PIMA COUNTY
FLOOD CONTROL

MEMORANDUM

SUBJECT: **Evaluating Effects of Rosemont Mine on Downstream Flows at Davidson Canyon**

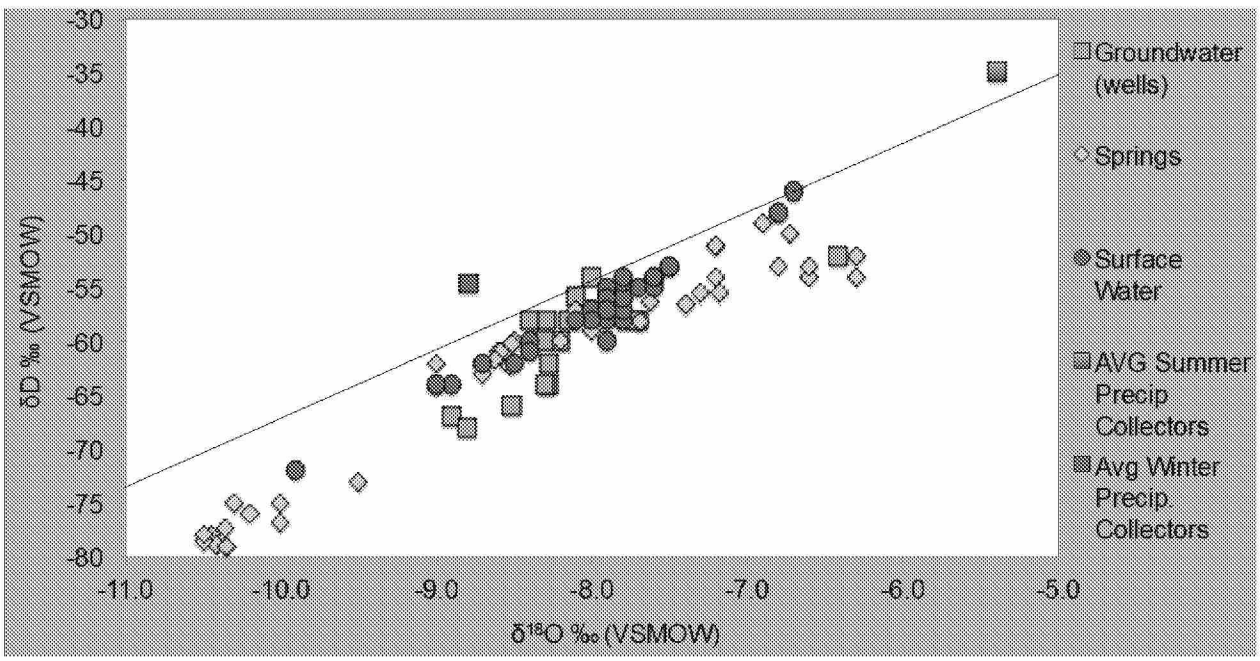
3.) **<u>The Isotopic Data indicates That Flows in Davidson Canyon and Ciengega Creek Suggest Derivation from Winter Storms</u>**

Recently collected isotopic data (McIntosh and Tucci, Unpublished data) indicate surface waters in Davidson and Cienega Creek more closely resemble winter precipitation, which disproportionately occurs at higher elevation (such as the mine site) suggesting a higher elevation source for the water in the Outstanding Waters.

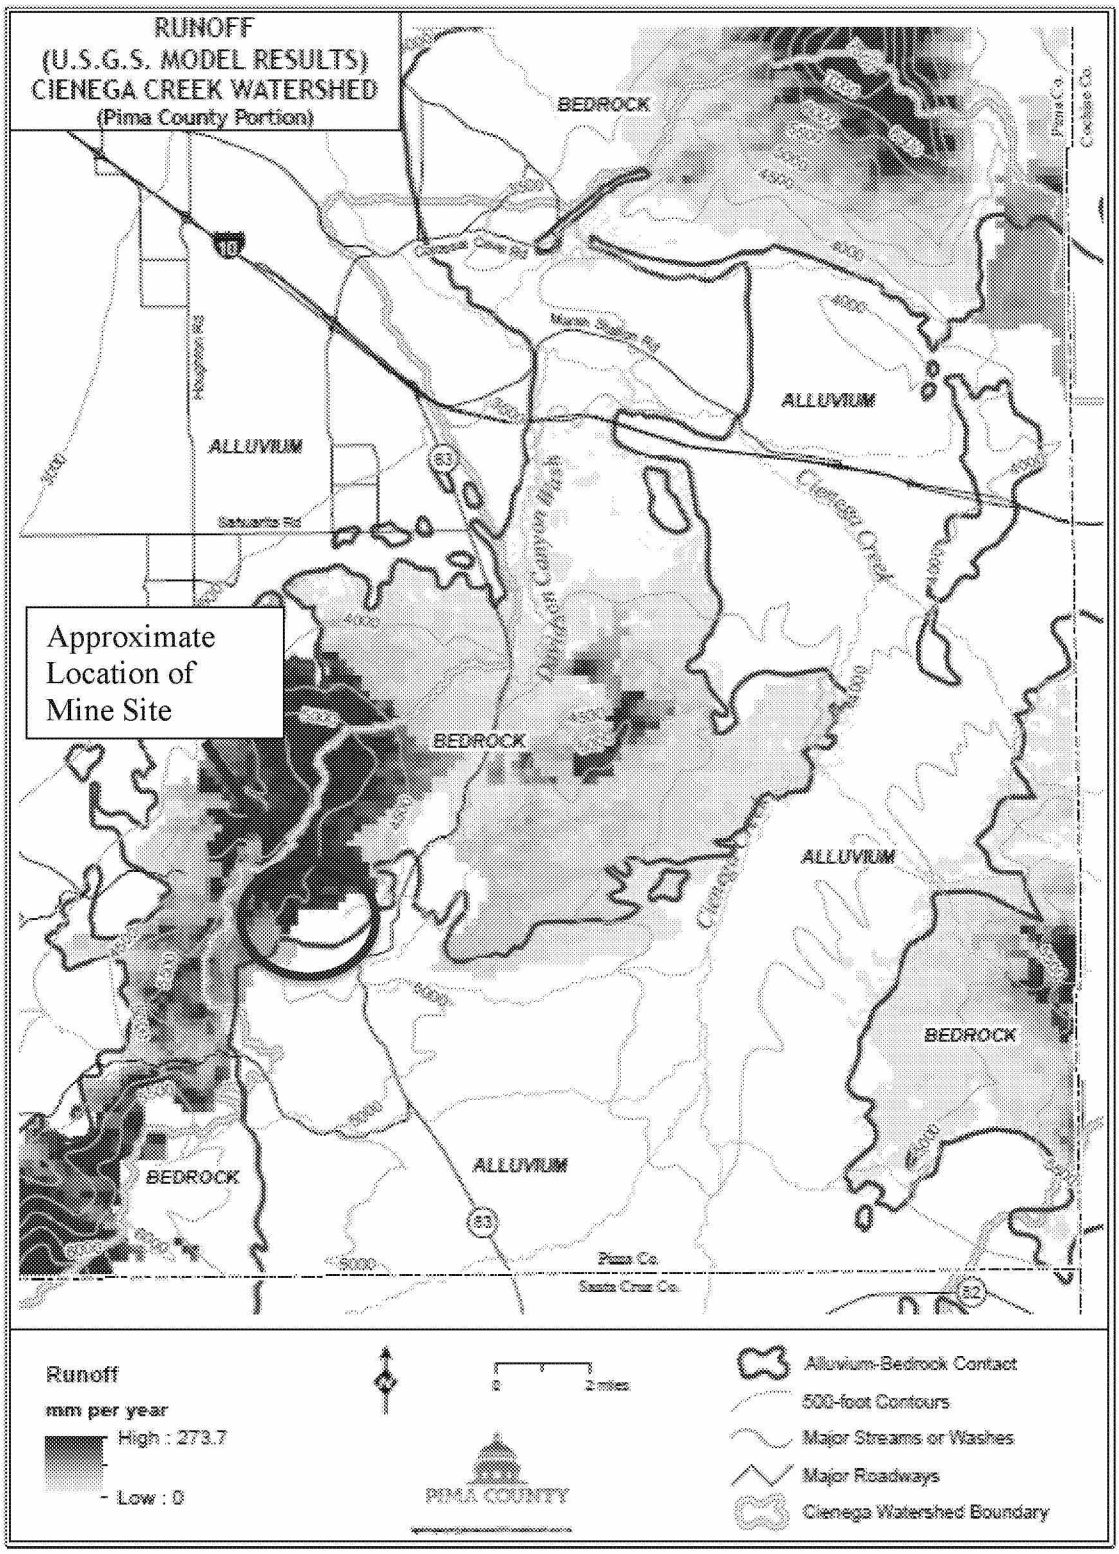
Simplified Available Groundwater Recharge and Runoff Estimate (e.g. Flint and Flint, 2007 – Graphic Attachment A), and has been done for the larger Rillito Watershed on a 270m grid.
